PRODUCT/PROCESS CHANGE NOTICE (PCN)

PCN #: **TB0812-05** DATE: **1/27/2009**
 Product Affected: **7 mm x 7 mm TQFP-48 shipped in tray**
 Date Effective: **4/27/2009**

ATTACHMENT I - PCN #: TB0812-05

Existing Shipping Tray - Peak

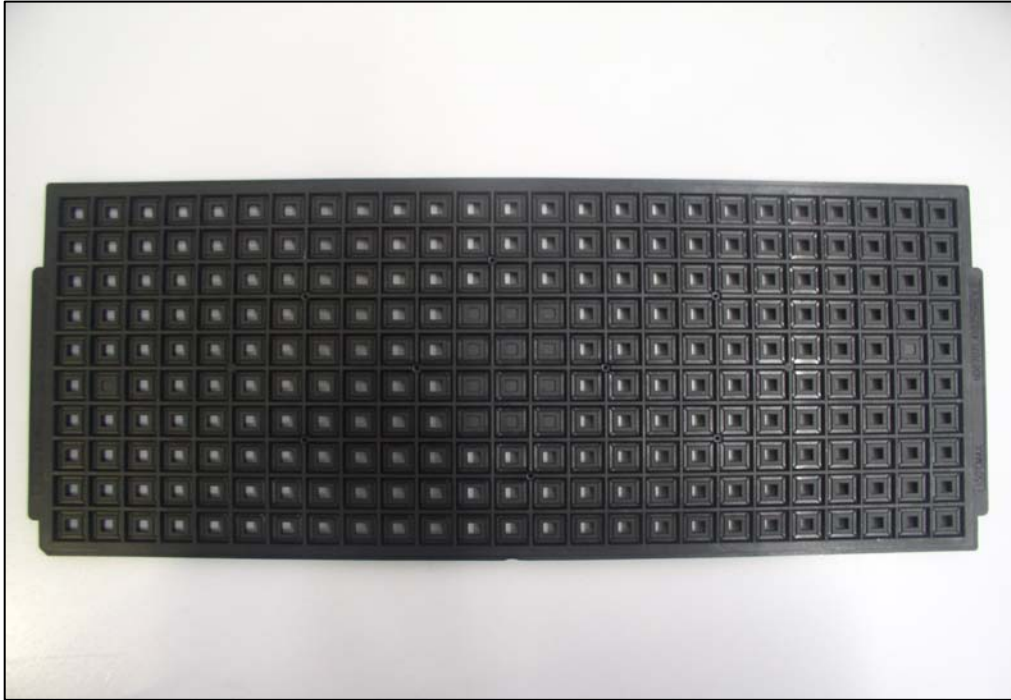
Detail of Change: This notification is to advise our customers that IDT has added alternate shipping tray for 7 mm x 7 mm TQFP-48 of PCA products shipped from IDT Malaysia.

There will be no changes in number of units per tray and tray's row /column pitch dimensions. Hence, customer may receive shipments consist of both the existing shipping trays and alternate shipping trays.

Alternate Shipping Tray - HLS

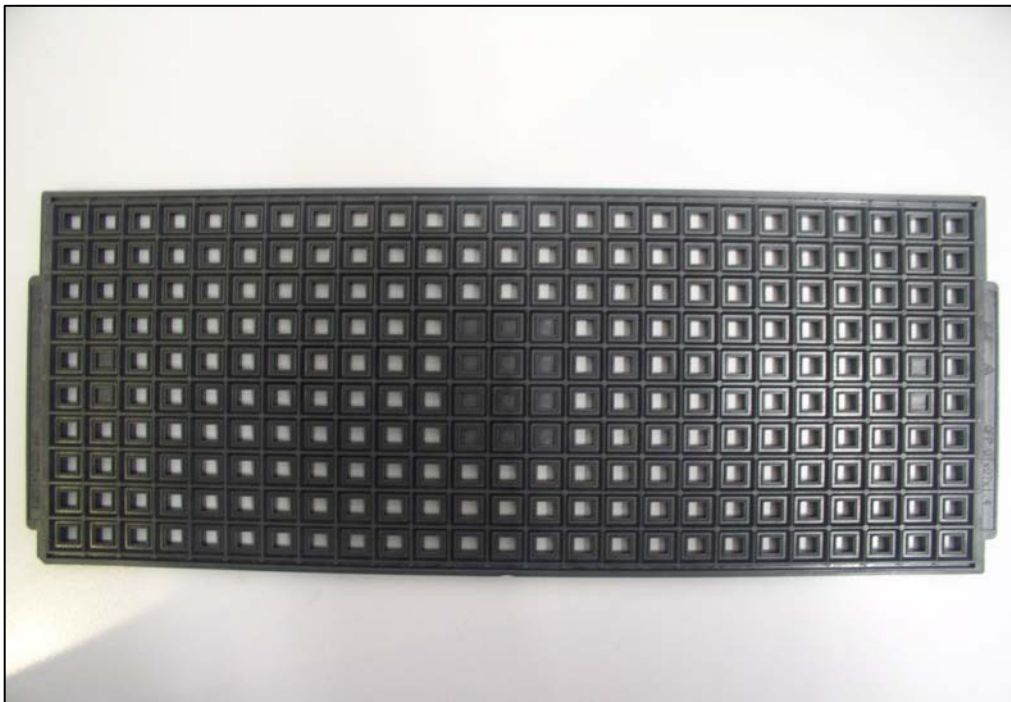
Description	Existing Shipping Tray	Alternate Shipping Tray
Supplier	Peak	HLS
Supplier Part Number	ND07071.4 1025 6 Rev B	QFP 07071410253
Tray Matrix	10 X 25	10 X 25
Qty per Tray	250 units	250 units
Rating Temperature	150°C	150°C
Tray Material	PP6	PSU
Pocket Size (WxL)	6.92 X 6.92 +/- 0.04 mm	6.89 X 6.89 + 0.05/-0.03 mm
Row Pitch	12.60 mm	12.60 mm
Column Pitch	12.20 mm	12.20 mm
Tray Drawing Number	MSC-5798	MSC-4798
